APPLICATION NO.	FILING DATE	FIRST NAMED INVENTOR	ATTORNEY DOCKET NO.	CONFIRMATION NO.
10/715,288	11/17/2003	Gareth G. Hougham	YOR920030496US1	7006

Office Action Summary	Application No. 10/715,288	Applicant(s) HOUGHAM ET AL.	
	Examiner Larisa Z. Tsukerman	Art Unit 2833

DETAILED ACTION

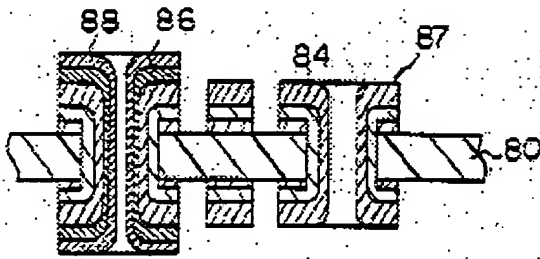
Claim 1 is rejected under 35 U.S.C. 102(b) as being anticipated by Anselmo et al. (4381134).

In regard to claim 1, Anselmo et al. disclose an interposer 11 comprising an electrically insulating carrier 11, an electrically conductive via 13 disposed in the carrier 11 and an electrical connector 20 that comprises a hollow body 23-26 of electrically conductive material that is disposed in electrical contact with the via 13 on opposite sides of the carrier 11 and that

has a plurality of surface voids (not marked, aria 25, 23 at the top and 31, 23 at the button, see Figs. 2 – 3) so that the electrical connector 20 accommodates forced physical and electrical contact with at least one separate electrical contact (see Abstract, lines 4-5).

Attachment 1

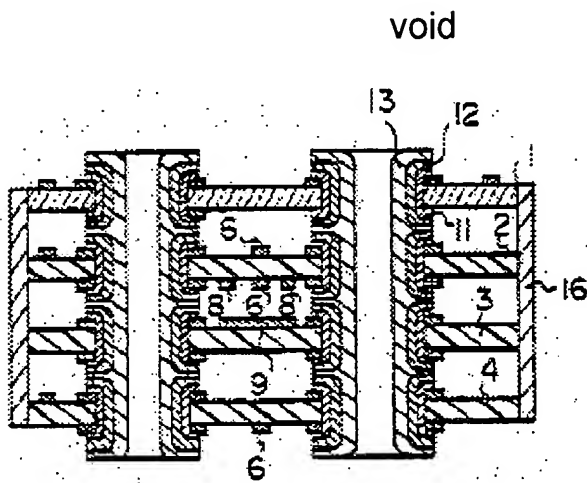
In regard to claim 1, Kurosawa et al. disclose an interposer (not marked, see Attachment 1) comprising an electrically insulating carrier 80, an electrically conductive via 10 (Fig.1C) disposed in the carrier 80 and an electrical connector 84, 87 that comprises a hollow body (not marked) of electrically conductive material that is disposed in electrical contact with the via 10 on opposite sides of the carrier 80 (see Fig. 9D) and that has a plurality of surface voids V (see Attachment 1) so that the electrical connector 20 accommodates forced physical and electrical contact with at least one separate electrical contact.

In regard to claim 4, Kurosawa et al. disclose the hollow body 86, 88 comprises at least two voids V (see Attachment 1) in registration with one another and disposed on opposite sides of the carrier 80.

In regard to claim 5, Kurosawa et al. disclose the carrier 80 comprises a plurality of the electrically conductive vias V (see Attachment 1) each disposed in electrical contact with a different one of a plurality of the hollow bodies 86/88.

Attachment 2

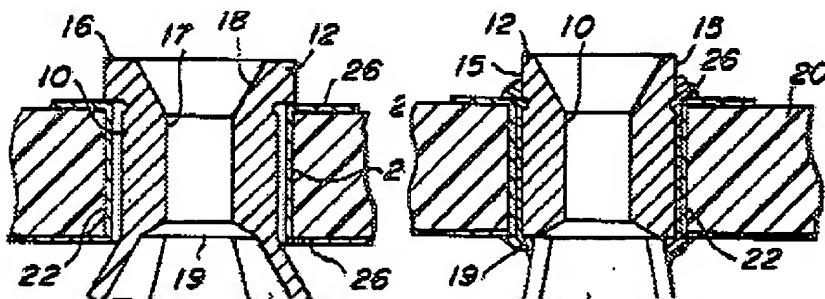
In regard to claim 1, DeSantis et al. disclose an interposer (not marked, see Attachment 2) comprising an electrically insulating carrier 20, an electrically conductive via 22 disposed in the carrier 20 and an electrical connector (socket) 12, 10, 14 that comprises a hollow body 10 of electrically conductive material that is disposed in electrical contact with the via 22 on opposite sides of the carrier 20 (see Figs. 3 - 4) and that has a plurality of surface voids 18 so that the electrical connector 12, 10, 14 accommodates forced physical and electrical contact with at least one separate electrical contact.

In regard to claim 4, DeSantis et al. disclose at least two of the surface voids 18 are in registration with one another and disposed on opposite sides of the carrier 20.

In regard to claim 5, DeSantis et al. disclose the carrier 20 comprises a plurality of the electrically conductive vias 22 each disposed in electrical contact with a different one of a plurality of the hollow bodies 10.

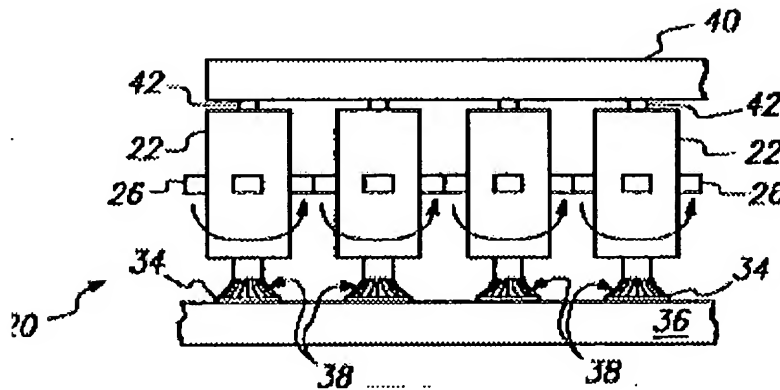
In regard to claim 41, DeSantis et al. disclose at least one of the voids is located to receive an optical signal so that the hollow body 10 is capable to accommodate both optical and electrical signals.

Attachment 4

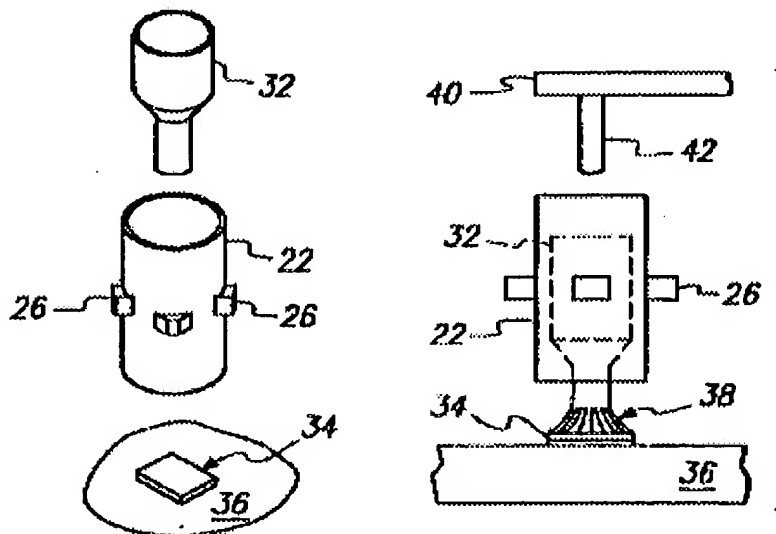
In regard to claim 6, Matsuba et al. disclose an interposer (not marked, see Attachment 4) for connecting a module 40 to a printing wiring board 36, comprising:

a carrier 20 that has at least one electrically conductive via (not marked, see Col.6, line 67 and Col.7, lines 1-3) and that is disposed so that the via is in registration with a connector 42 of the module 40 and a connector 34 of the printed wiring board 36, and at least one electrical contact button 32 that is hollow (see Fig. 4), that is disposed in the via (see Col.6, line 67 and Col.7, lines 1-3) for forced physical and electrical contact with the connector 42 of the module 40 and the connector 38 of the printed

wiring board 36 and that has at least one surface void V (not marked, see Attachment 4).
